## Appendix C

### Detailed Response to Submissions

#### 1.1 Department of Planning, Housing and Infrastructure

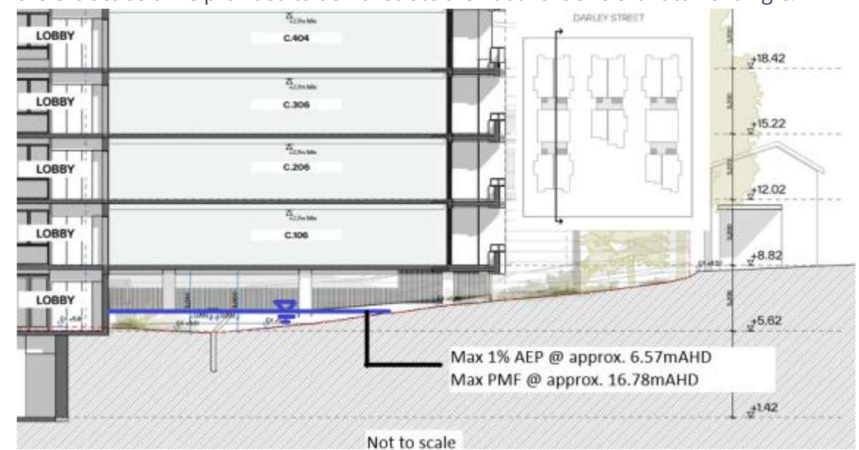
Map 19 of the FIRA shows 1% AEP flood levels around Building C at approximately 6.5m Australian Height Datum (AHD) and a floor level of 5.82m AHD. However, the Architectural Drawings show a floor level of 5.62m AHD. CPHR advises that the required freeboard to the 1% AEP flood level has not been provided in the Architectural Drawings.

Map 26 of the FIRA appears to show PMF inundation immediately adjacent to the main area of Building C. The basement and any areas connected to the basement should be protected against PMF inundation.

Showing flood levels on the relevant architecture drawings, including Elevation – Building C on DA202 and Section A on DA300, would assist in the review of the floor level requirements.

- Revise the floor level of Building C to be above the flood planning level.
- Ensure all openings to the basement are above the PMF level.

Updated Architectural Drawings (Drawing DA300) have been prepared by PBD Architects (**Appendix D**). These include a building section, identified as Section A, and the extract below is provided to demonstrate the floor levels relevant to Building C.
